Our Ref: SHF.1671.006.HY.LT.001.A

Garstang Road, Broughton, Preston, PR3 5JA – LLFA Objection Response Letter

Application Number:	06/2023/0030
Proposal:	Outline planning application seeking approval for access only for residential development for up to 51no. dwellings with associated works (all other matters reserved)
Location:	Land west of Garstang Road, Broughton, Preston, PR3 5JA

DRAWING TITLE:
Outline Surface and Foul Water Drainage Strategy

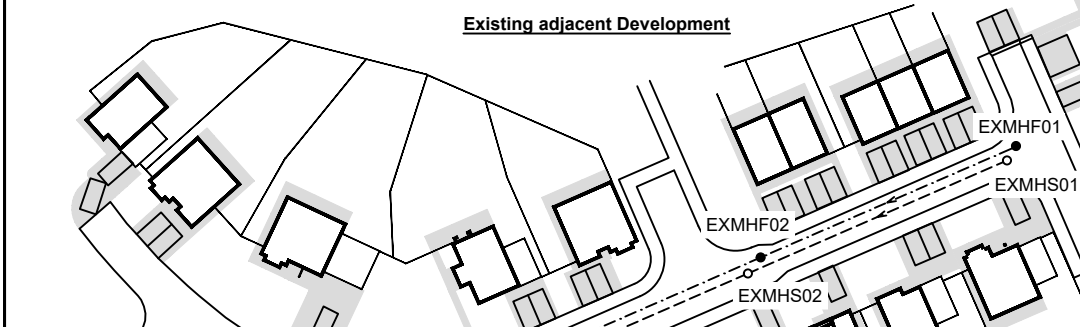
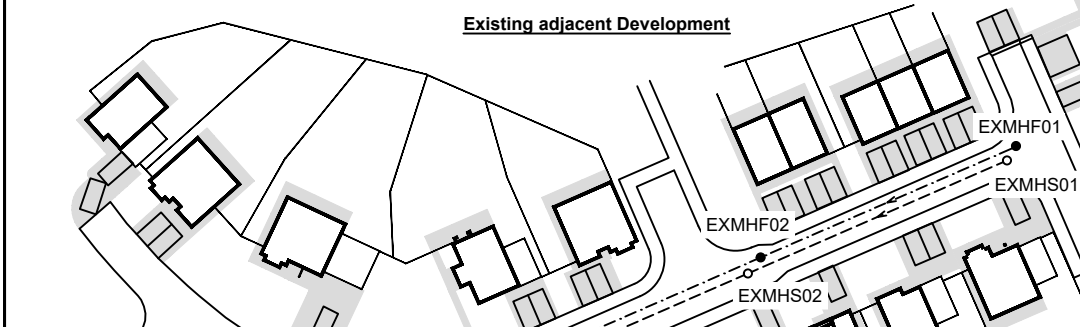
- The climate change allowances were updated on 10th May 2022.
- The applicant will need to apply a 10% urban creep allowance in the drainage design in accordance with British Standard BS 8582.
- If the applicant is only modelling the impermeable area of the development, then an appropriate runoff coefficient (Cv) value needs to be applied to the drainage calculations. The default Cv values (0.84 and 0.75) apply when modelling a mixture of impermeable and permeable surfaces. A Cv value of 1.0 should be applied when modelling impermeable areas.

- **Provide appropriate minimum operation standards for peak flow and volume control**, in line with the Defra Technical Standards for Sustainable Drainage Systems, therefore, is contrary to paragraph 169 of the National Planning Policy Framework.

The submitted surface water sustainable drainage strategy states that surface water from the site will be discharged at greenfield Q_{bar} rates but fails to contain surface water volume flows within this parameter, as set out in Standard S6 of the Defra Technical Standards for Sustainable Drainage Systems. This is because a 40% allowance has incorrectly been added to the Q_{bar} greenfield runoff rate which is unacceptable. Climate change allowances are added to a sites attenuation requirements, not the sites discharge rate. This is sufficient reason in itself for a refusal of planning permission.

- **Provide an appropriate allowance for climate change**, in line with [national guidance](#) and, therefore, does not have appropriate minimum operation standards for the lifetime of the development, contrary to Paragraph 169 of the National Planning Policy Framework. Failure to provide an appropriate allowance for climate change will result in increased flood risk on and off site over the lifetime of the development. This is considered contrary to Paragraph 167 of the National Planning Policy Framework and therefore sufficient reason in itself for a refusal of planning permission.

We have updated climate change to the current 50% allowance for the Ribble Management Catchment, applied 10% for urban creep, and used the 1.0 runoff coefficient to the revised drainage calculations. Revised drainage calculations and drawing are included in Attachments 2 and 3 respectively.

P03	03/02/23	Drainage design amended in line with LLFA comments	EA	RB	DA
P02	06/07/21	Final site layout added & drainage moved	EA	DA	DA
P01	14/05/21	First Issue	CH	WW	EA
REV:	DATE:	DETAIL:	DES:	CHK:	APP:

Flow Control
Hydro-brake
Design Depth: 1.50m
Allowable Discharge (Qbar): 19.4l/s
Downstream hydrobrake to be adjusted.

Surface Water Attenuation Basin
Designed for 1 in 100yr +50%CC
Attenuation Volume: 965m³
Top of Bank: 40.800
Max Water Level: 40.500
Min Water Level: 39.000
Bed Level: 38.700
Freeboard: 0.300m
Basin Banks: 1:4
